Cermet-Coated Piston Rings for Operation on Low-Sulphur Fuels (0.5% S or lower)

Including LNG, LPG, methanol and ethane
Replaces SL2016-633/JAP

SL2018-659/JAP

Owners and operators of MAN B&W two-stroke marine diesel engines.
Type: MC/MC-C, ME/ME-C, ME-B, ME-GI, ME-GIE and ME-LGI

Fig. 1: The CPR ring pack containing three high rings with cermet-coating on all rings for pistons with three grooves. This ring pack is also available in a configuration with one high and two low rings.

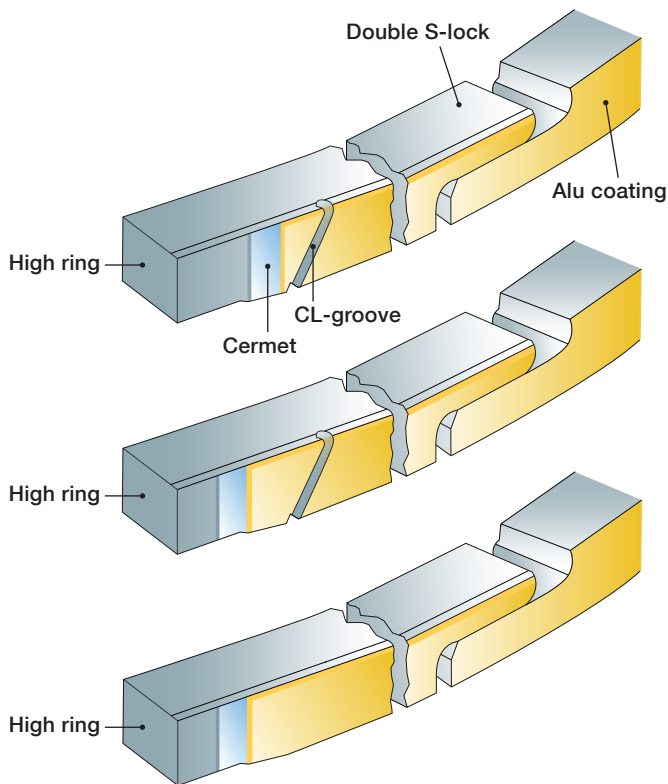
When applying hard cermet-coating to the piston ring running side, see Figs. 1 and 2, the margin towards scuffing increases. The cermet will recover after an incident, provided the situation is timely discovered and action is taken to ensure that the development is stabilised. This requires increased lubrication and a reduction of the load (SL2014-587/JAP). However, the liner may need machining at the next overhaul to ensure proper running-in of the new rings.

Fig. 1 shows a three high-ring configuration for piston crowns with three grooves. To order the piston rings see the attached plate 8872-2272-0010. A three-ring configuration with one high- and two low-rings for piston crowns with four grooves, is also available, see attached plate 8872-2272-0011. When using a three-ring configuration for a crown with four grooves, the lowest groove must be left empty, see SL2016-611/JAP. Fig. 2 shows the 2020 CPR ring pack, see also plate 8872-2272-0005.

If the engine is already operating on VLSFO or ULSFO fuel, or if it is intended to do so after 1 January 2020, we recommend to install cermet-coated rings at the next scheduled overhaul.
